WATTS BAR NUCLEAR PLANT (WBN) - UPDATED FINAL SAFETY ANALYSIS
REPORT (UFSAR) CHANGE PACKAGE 1553

SAR CHANGE PACKAGE NO. 1553

Document No: UFSAR Change 1553, EDC E-50045 Rev. 0

FSAR change package 1553 documents changes resulting from a review of Section 7.2. A copy of the section showing the changes is attached. The attachment contains reference numbers near each change which correspond to the item numbers used in this SA/SE. Some items appear several times. Items 1-15 and 17-38 are corrections of non-numerical typographical errors, administrative changes, or minor editorial changes that do not change the intent. As such, they are considered to be non-significant changes as defined in NADP-7, Section 5.0, and do not require an SA, SR or SE. Therefore, these non-significant changes will not be further addressed. Item 1 includes those non-significant changes for which no explanation is needed. The remaining items (16 and 39) will be addressed in the Screening Review and Safety Evaluation. Design basis document changes are being made by EDC E-50045 to ensure consistency with existing design and licensing bases, including changes associated with the UFSAR changes described below.

POWERHOUSE
UNIT 1
ELECTRICAL
LOGIC DIAGRAM
REACTOR PROTECTION SYS
TVA DWG NO. 1-478611-99-6 R2
FIGURE 7.2-1 SH 3

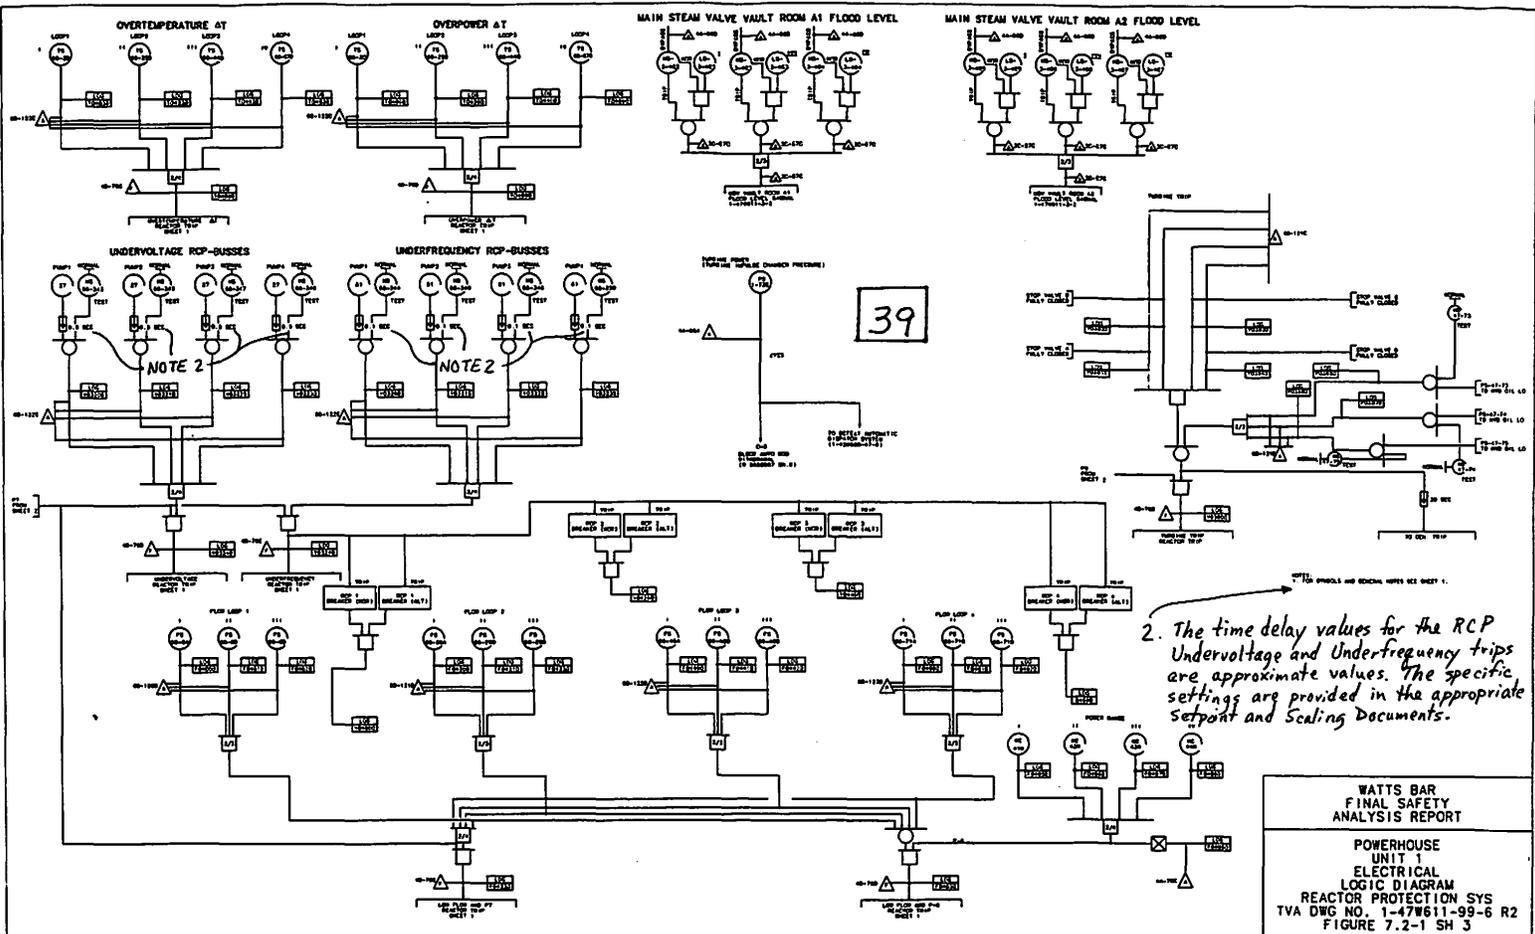
39 (Figure 7.2-1 Sheet 3): This drawing, 1-47W611-99-6, shows time delays of 0.5 and 0.1 seconds, respectively, for Reactor Coolant Pump undervoltage (UV) and underfrequency (UF) reactor trip signals. NE SSDs specify settings of 23 cycles (0.383 sec) for the UV and 5 cycles (0.087 sec) for the UF as determined by calculations WBPE0689009007 and WBPE0689009008. This discrepancy is documented in WBPER980417. The drawing will be revised by DCN E-50045.

39 (Figure 7.2-1 Sheet 3): This drawing, 1-47W611-99-6, shows time delays of 0.5 and 0.1 seconds, respectively, for Reactor Coolant Pump undervoltage (UV) and underfrequency (UF) reactor trip signals. Setpoint and Scaling Documents specify settings of 23 cycles (0.383 sec) for the UV and 5 cycles (0.087 sec) for the UF as determined by calculations WBPE0689009007 and WBPE0689009008. This discrepancy is documented in WBP980417. The drawing will be revised by DCN E-50045.

- Drawing 1-47W611-99-6 (Figure 7.2-1 Sheet 3) shows time delays of 0.5 and 0.1 seconds, respectively, for Reactor Coolant Pump undervoltage (UV) and underfrequency (UF) reactor trip signals. The Setpoint and Scaling Documents (SSDs) specify settings of 23 cycles (0.383 sec) for the UV and 5 cycles (0.087 sec) for the UF as determined by calculations WBPE0689009007 and WBPE0689009008. The values on the drawings were not used in establishing the settings and the actual settings are based on the SSDs. No plant modifications are required. The drawing will be revised by DCN E-50045.

Item 39: The actual relay settings for the time delays for the Reactor Coolant Pump undervoltage and underfrequency reactor trip signals are based on NE SSDs which reflect the results of uncertainty calculations WBPE0689009007 and WBPE0689009008. The time delay values shown on drawing 1-47W611-99-6 were not used in setting the relays or in the uncertainty analyses. Therefore, no protection system parameters are affected by this discrepancy.
